Notice of Intent

Sundry ID: 2660970

Type of Action: Plug and Abandonment

Oakason NV Federal 3
30-015-24095
Lease # NM-12246
2030'FNL & 1650'FEL
Unit Letter G-34-19S-24E
Eddy County, New Mexico

Oakason NV Federal 3 Proposed

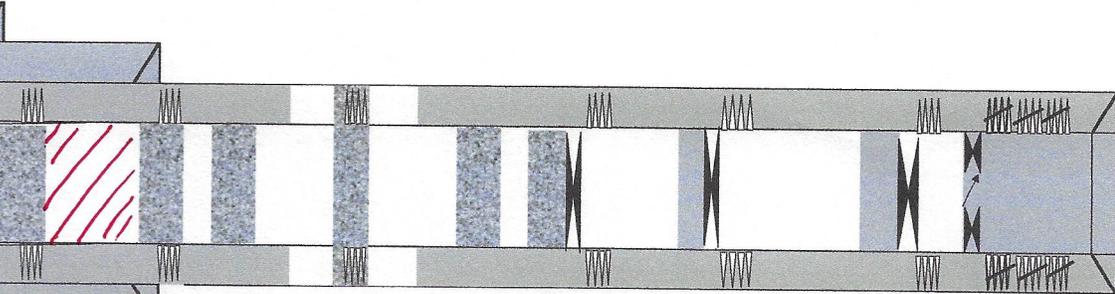
1. MIRU all safety equipment as needed. NU BOP. POOH with production equipment.
2. Set a CIBP at 7292'. Pressure test. Spot 25 sx Class C cement on top of CIBP to 7047'. WOC and tag. This will cover Wolfcamp top. *5378' to 5110'*

3. Spot a ~~25~~³⁰ sx Class C cement plug from ~~5266-5021'~~. This will cover Wolfcamp top.
4. Perforate at 3999'. Attempt injection rate. Squeeze with 33 sx Class C cement from 3999'-3859'. WOC and tag. This will cover Abo top.

5. Spot a 25 sx Class C cement plug from 1818'-1573'. This will cover Glorieta top. *1843' to surface*
6. Perforate at ~~1015'~~. Attempt injection rate. Spot a ~~25~~ sx Class C cement plug from ~~1015'-770'~~. WOC and tag. This will cover casing shoe. *450sx Perf @ 1843'*

9 - Spot from 4930' to 4780'. WOC & TAG (25 sx) (B. Salt)

| Plug Type | Top | Bottom | Length | Tag | Sacks | Notes |
|-------------------------------|---------|---------|---------|--|--------|--|
| Top of Salt @ 1843 | 1774.57 | 1893.00 | 118.43 | Tag/Verify | 450.00 | Spot from 1843' to surface. Verify at Surface. |
| Base of Salt @ 4880 | 4781.20 | 4930.00 | 148.80 | Tag/Verify | 25.00 | Spot from 4930' to 4780'. WOC and Tag. |
| Delaware @ 5328 | 5224.72 | 5378.00 | 153.28 | If solid base no need to Tag (CIBP present and/or Mechanical Integrity Test), If Perf & Sqz then Tag, Leak Test all CIBP if no Open Perforations | 30.00 | Spot from 5378' to 5110'. |
